Report to Development Permit Panel

File: DP 24-012854

Re: **Application by SD Railway Homes Inc. for a Development Permit at
8520 Railway Avenue**

01 BUILDING SECTION 1
A-3.01 SCALE: 1/8" = 1'-0"

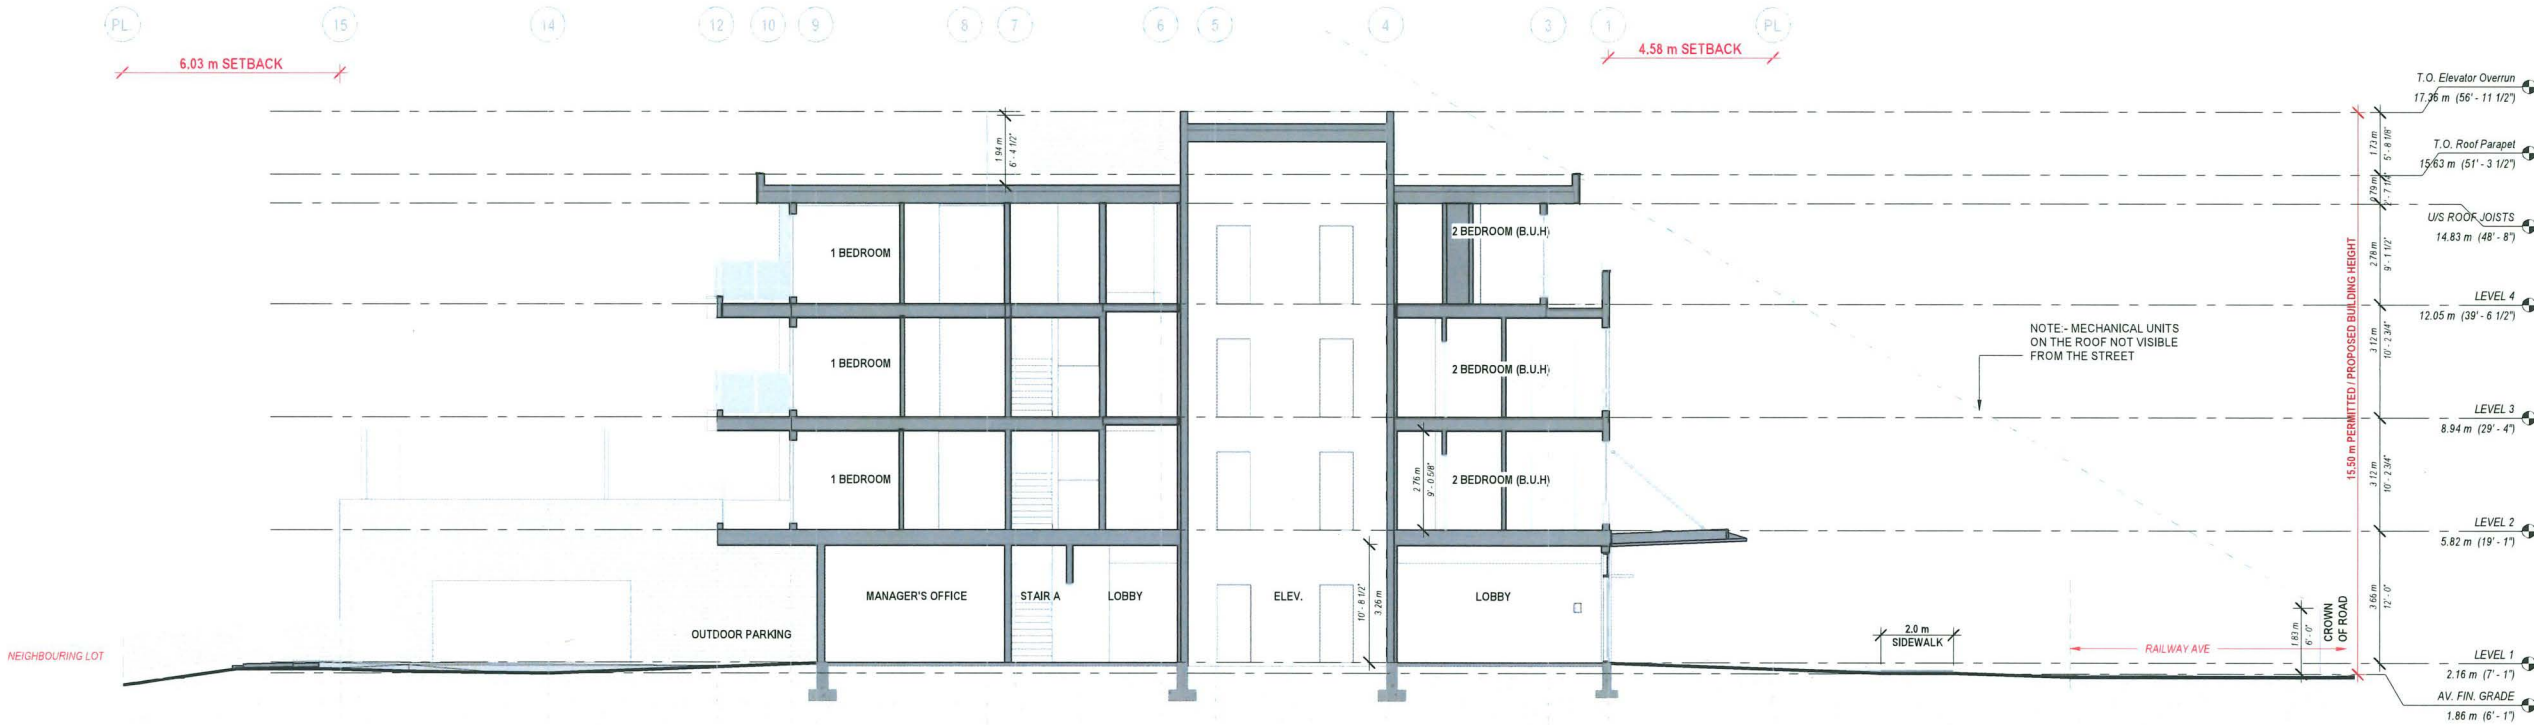
- the raised 42-inch high planter areas at the eastern edge of the roof terrace serve to exacerbate the height as it relates to the dwellings to the east; there appears to be significant structural height within the parkade and inseting the plantings would help to use that space productively while reducing height impacts; a lighter guardrail could be implemented to maintain safety at the roof terrace;

The Level 2 outdoor amenity terrace has been lowered by 1'-0" to mitigate the condition. The continuity of guardrail materiality is an integral component of the facade architectural expression. Additionally, recessing the planters at Level 2 would significantly reduce the effective useable area of the amenity space. - REV01.

1 TRELLIS WITH METAL ROOF
Scale: 1:25

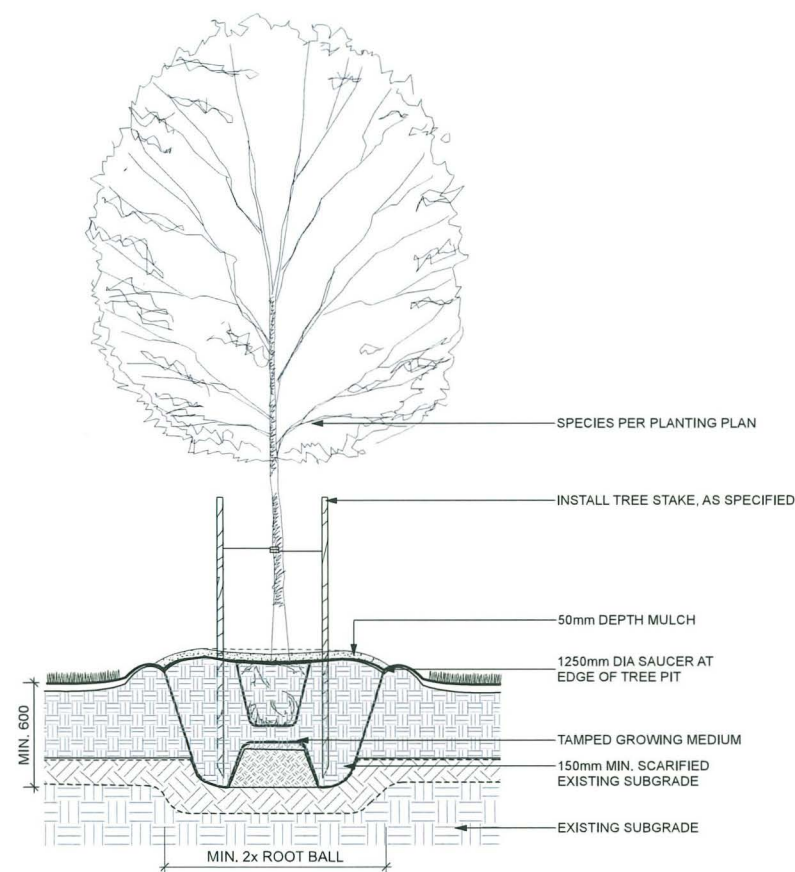
- the proposed shared outdoor amenity space on Level 2 is successful; however, it does not provide weather protection for a potentially well used area; consider providing weather protection for the shared outdoor amenity space to make the space useful during rainy or sunny days;

Landscape response: A trellis with a metal roof has been proposed at the south end of the Level 2 outdoor amenity space to provide weather protection.
